**DIRECT TESTIMONY
AND EXHIBITS OF
PETER J. LANZALOTTA,
LANZALOTTA & ASSOCIATES LLC
On Behalf of the Maryland
Office of People's Counsel**

December 4, 2009

Figure 1

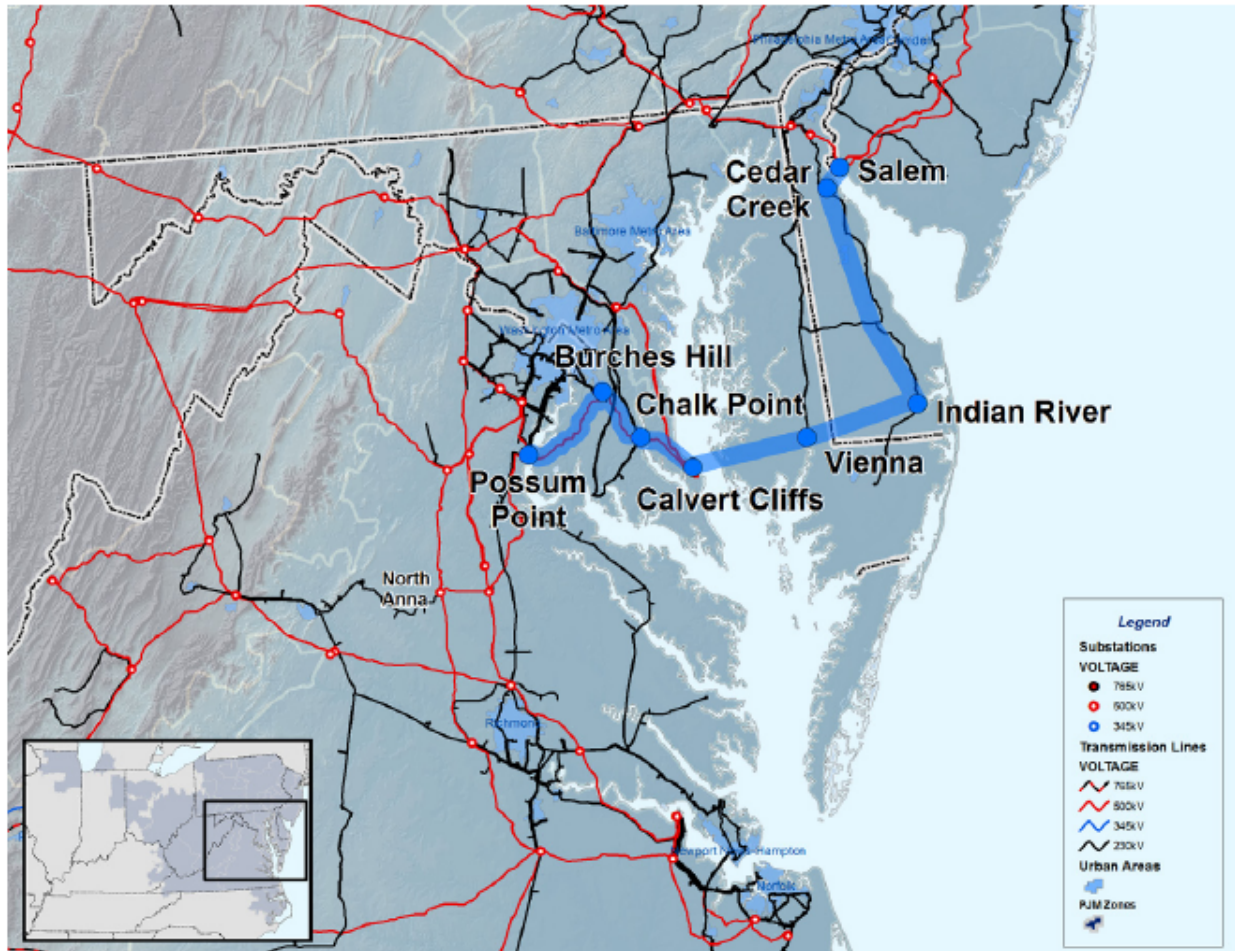
1 A. Figure 1 below is an excerpt from the PJM 2008 RTEP³ which shows eastern Maryland,
2 eastern Virginia, Delaware, southern Pennsylvania, and southern New Jersey, and which
3 depicts an approximation of the proposed MAPP transmission line⁴, and related
4 segments. The proposed MAPP transmission line, and its related segments, are shown as
5 a thick line that runs from Possum Point to Burches Hill to Chalk Point to Calvert Cliffs,
6 across the Chesapeake Bay to Vienna and Indian River. The thick line between Indian
7 River and Salem was once also part of MAPP, but has been deferred by PJM from
8 current consideration, due mostly to reductions in peak load forecasts.

⁴ In actuality, the proposed route of the transmission line may be different from that depicted in Figure 1.
